RE: GRADING & DRAINAGE PLAN OF ARROYO DEL OSO GOLF COURSE, CLUB
HOUSE & RESTAURANT, RECEIVED JANUARY 21, 1988 FOR BUILDING
PERMIT APPROVAL (F-18/D29)

Arroyo Del Oso Golf Course Club House Remodel & Addition

GRADING & DRAINAGE PLAN

C1

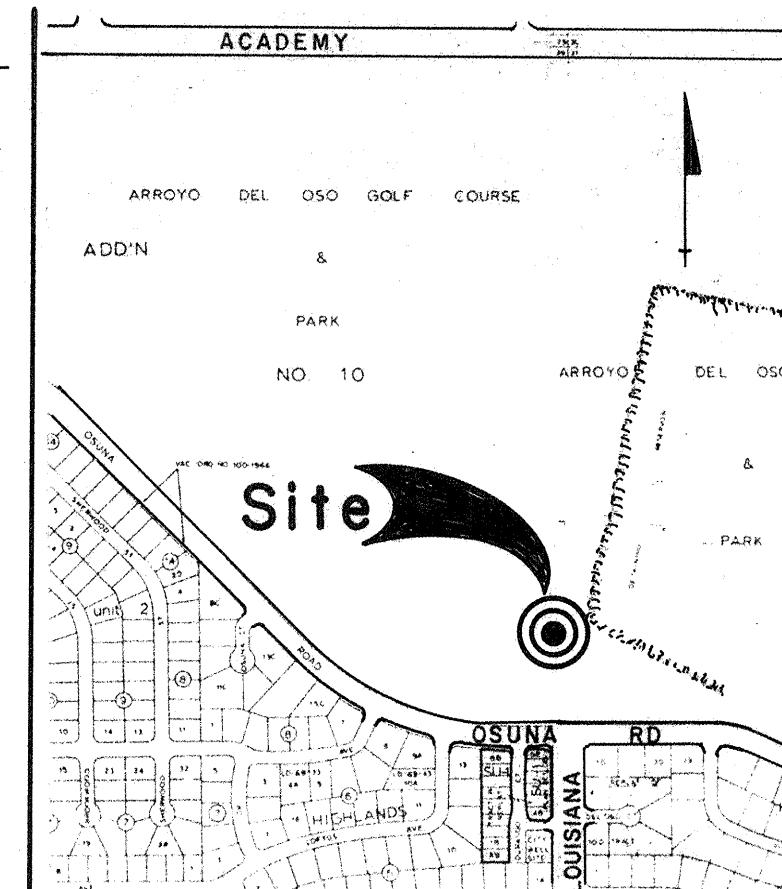
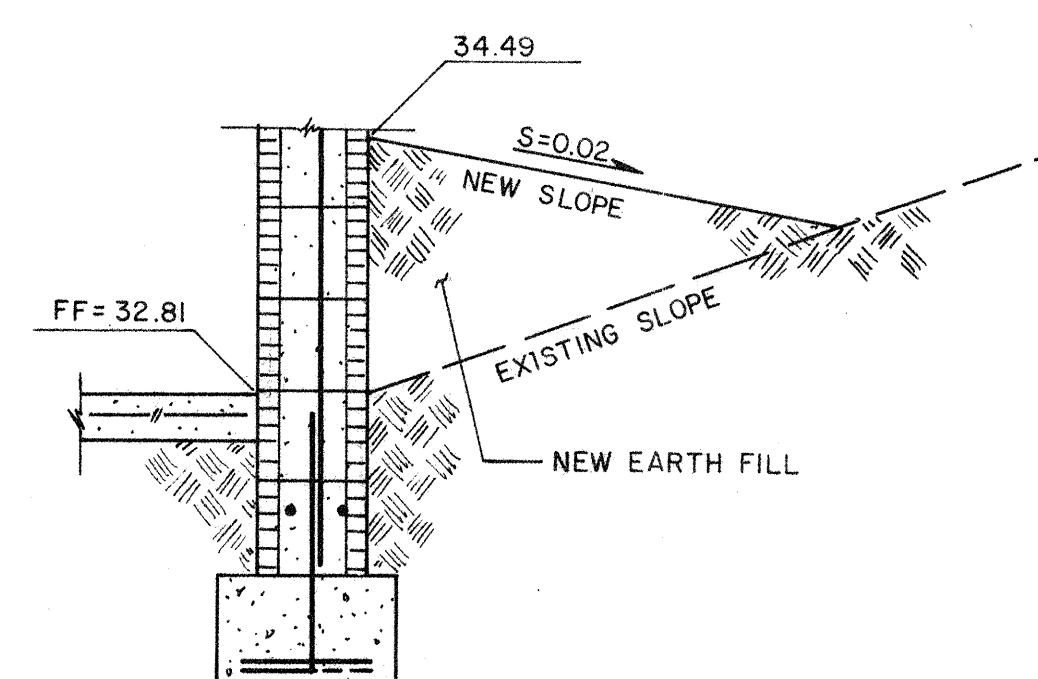
Based on the information provided on your submittal dated December 31,
1987, the above referenced plan is approved for Building Permit.

Please attach a copy of this plan to the construction sets prior to
sign-off by Hydrology. If the building permit has already been released,
it is your responsibility to see that the contractor has this approved
copy.
